Bank Canal, Gadawari Central Delta

Estimate of Rs 23,000 for Constructing a Combined Drainage outfall Sluice, Aqueduct & Canal Surplus at 42 3/4 mile of the ———— Approved & a copy of the nos. ordered to be forwarded to the Govt of India, for Sanction.

REPORT to accompany the Estimate for a combined new Under-tunnel and Surplus Weir at $42\frac{3}{4}$ mile, Bank Canal.

Note by the Acting Chief Engineer for Irrigation.

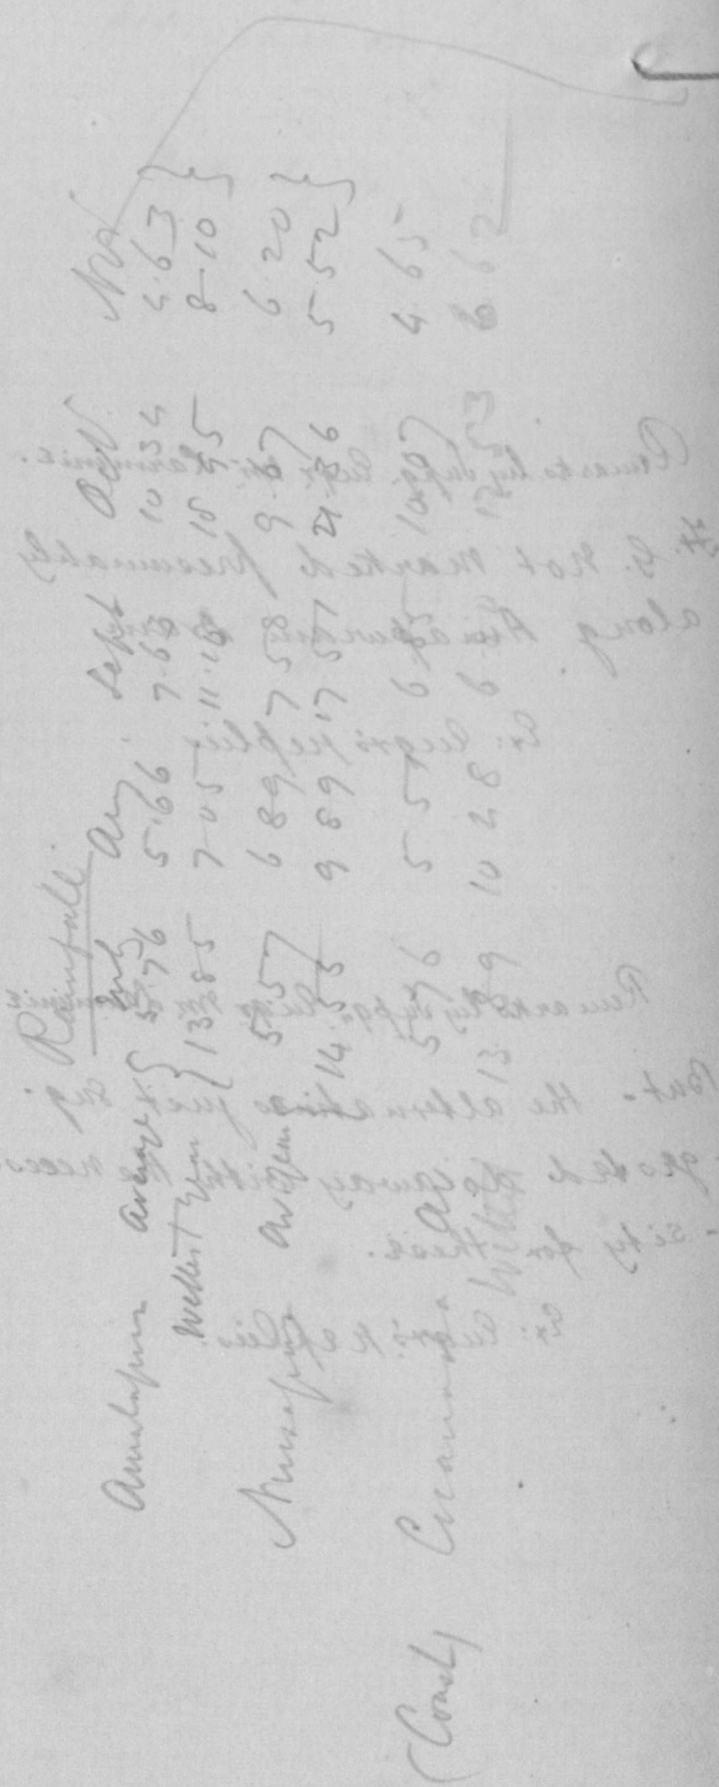
Remarks by Supg. Engr. Mr. Lammie.
 But will river usually be high
 when drains are in floods.
 Ex: Engr's replies.
 As the level of the low lands

Remarks by Supg. Engr. Mr. Lammie.
 H.G. Not marked presumably
 along Annapuram Drain.

Remarks by Supg. Engr. Mr. Lammie.
 But the alternatives just sug-
 -gested do away with the neces-
 -sity for these.

to be drained is only about +5.00
 the river is frequently too high bet-
 -ween July and October. The drains
 are often in flood in July & September
 and excess water in the former month
 does much damage to the recently
 transplanted paddy.

Ex: Engr's replies
 were marked in pencil now
 inked in.

Ex: Engr's replies.
 The other proposals were not sug-
 -gested as alternatives but as
 additional measures to be taken
 for the improvement of the drain-
 -age system. I consider that in
 any case Rangarajukodu Drain
 must be repaired & improved,
 the levels, survey etc. are now com-
 -pleted and estimates will be
 prepared as soon as orders are
 passed regarding the proposal to
 make the drain high enough to take
 the whole discharge of Amalapur Drain.
 The available fall for Rangarajukodu
 Drain is only about 4" per mile.
